**FINAL DRAINAGE REPORT FOR  
DRIFTWOOD ESTATES FILING NO. 1  
3275 CENTER ICE VIEW  
COLORADO SPRINGS, COLORADO 80918**

October, 2023

Job No. 2358.00  
PCD Filing No.: XXXXX

EXISTING DRAINAGE PLAN

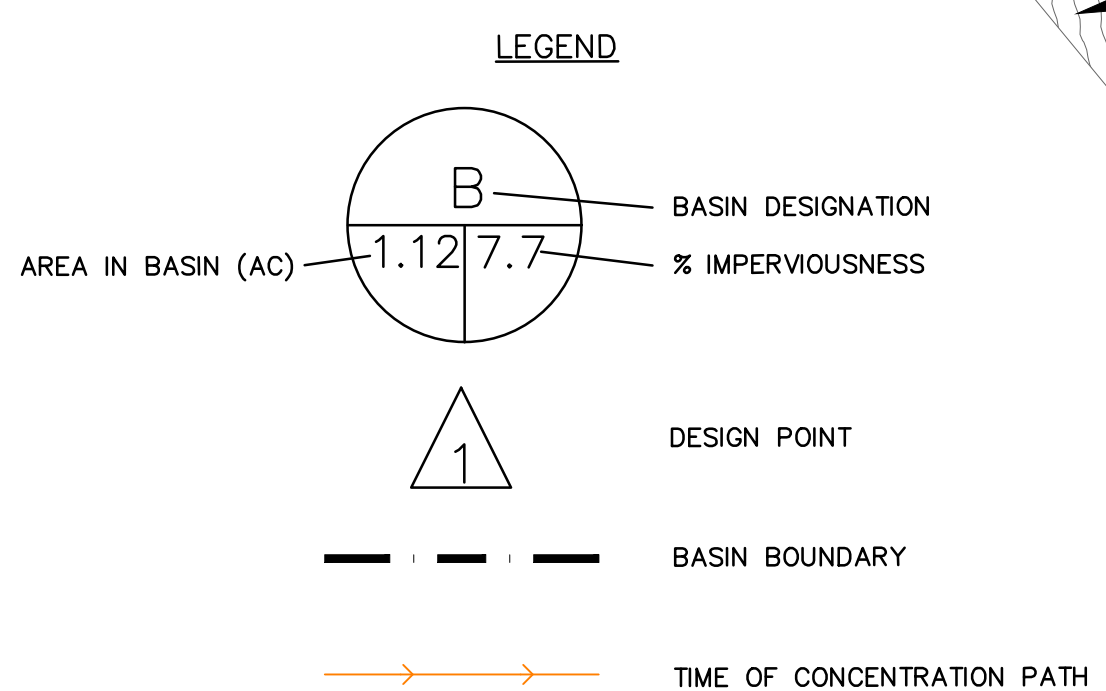
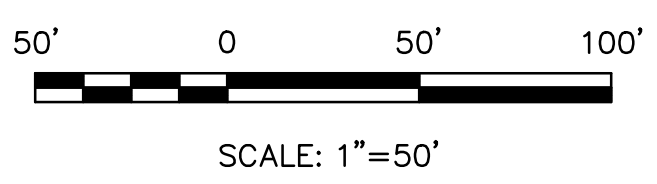
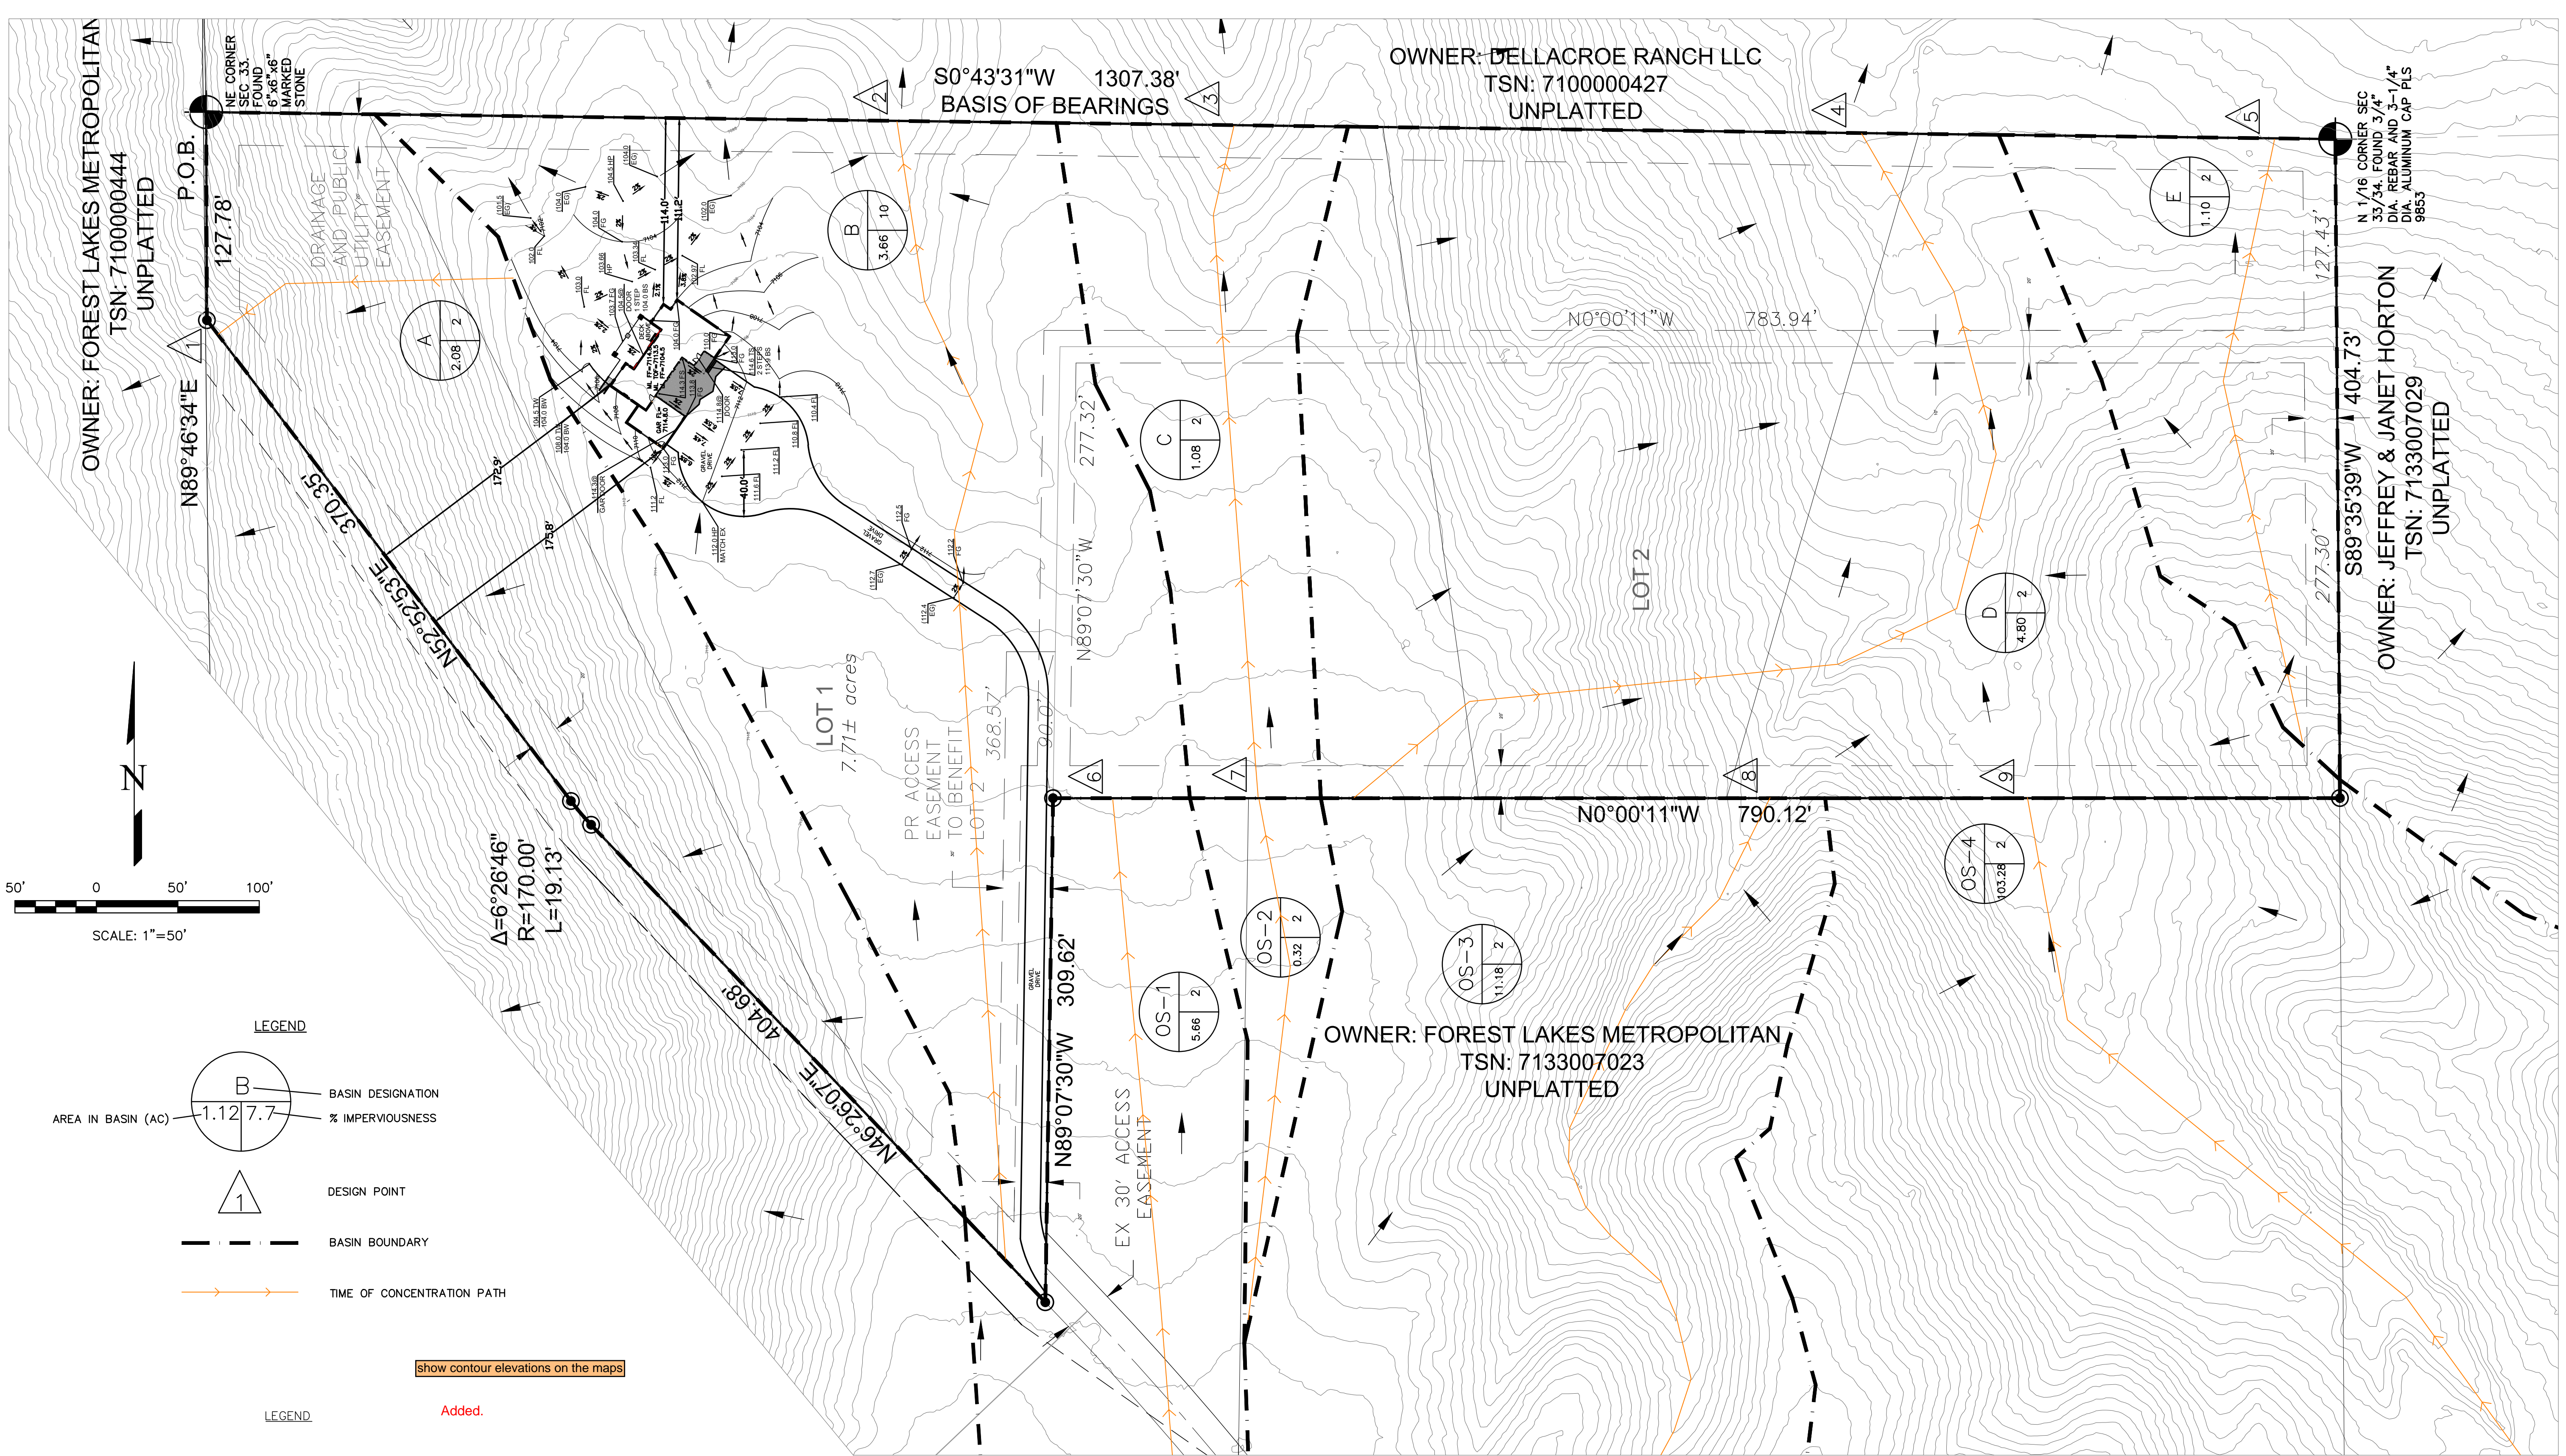
Show contour elevations on the maps  
Added.

PROPOSED DRAINAGE PLAN

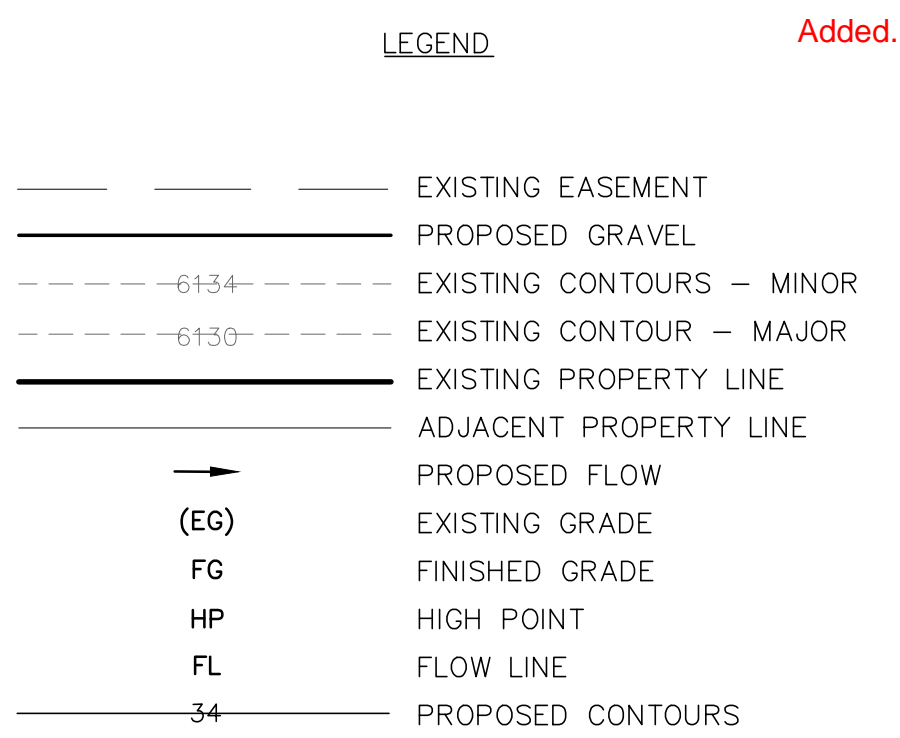
show contour elevations on the maps

In a narrative explain why the increase in flow is almost 1 cfs for basin B, which contains most of the development. How is a 17% increase considered negligible?

Added.

I think that 6.79 cfs is 114.5% of 5.93 cfs so we are slightly under a 15% increase. When taking that design point 2 as a whole the increase is from 11.75 cfs to 12.61 cfs which would be only a 7.3% increase from existing conditions. This increase is necessary to install a house and driveway but is not a significant impact to the area downstream.
